Access Compliance Report

Public Rights-of-Way

(Curb Ramps)

Intersection ID: 15581	Main Street: CLANTON_RD	Cross Street: ST_VARDELL_LN	Location: NW
ADA ID: AB5509B791B1	Ramp Type: PerpDiag	Initial Pass/Fail: Fail	Overall Compliance: No
		Severity Score: 8.75

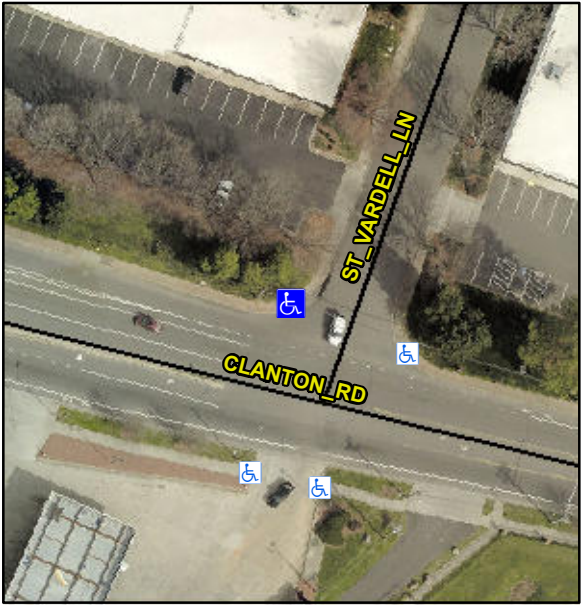
Codes/Mitigation Info/Possible Solution			Field Measurements/Component Compliance		
	Possible Solutions:		Compliance	Description	Data
	Remove & Replace Curb Ramp With Two New Directional Ramps or Equivalent.		Yes	Ramp Length (in)	71.0
			No	Ramp Width (in)	46.0
			N/A	Flare Type LT	N/A
			N/A	Flare Slope LT (%)	N/A
			N/A	Flare Traversable LT?	N/A
			N/A	Landing Length (in)	N/A
			N/A	Landing Width (in)	N/A
			N/A	Landing Slope (%)	N/A
			N/A	Landing X Slope (%)	N/A
<p>Surveyor Notes:</p> <p>N/A</p>			N/A	Flare Type RT	N/A
			N/A	Flare Slope RT (%)	N/A
			N/A	Flare Traversable RT?	N/A
			N/A	DWS Provided?	N/A
			N/A	DWS Contrast?	N/A
			N/A	DWS Length (in)	N/A
			N/A	DWS Full Width?	N/A
			N/A	DWS Offset (in)	N/A
			N/A	Shared Landing?	N/A
			N/A	Gutter Ponding?	N/A
<p>PROW/ADA:</p> <p>Not Found, R304.5.1</p>			N/A	Gutter X Slope (%)	N/A
			N/A	Gutter Lip Ht (in)	N/A
			No	Painted X Walk1?	No
				X Walk 1 Direction	To SW

N/A	X Walk 1 Width (in)	N/A
				X Walk 1 Slope (%)	1.5
				X Walk 1 X Slope (%)	1.4
			N/A	Ramp inside XWalk1?	N/A
			N/A	Ramp inside XWalk2?	N/A
			N/A	Road Slope (%)	0.2
<p>Total Cost:</p> <p>\$ 3200.00</p>			N/A	Clear Space?	N/A
			N/A	Clear Space to XWalk (in)	N/A
			N/A	Storm Grate/Utility Hazard?	N/A
				Storm Grate/Utility Type	
			N/A		N/A
			N/A	Surface Condition? (G/P)	Good
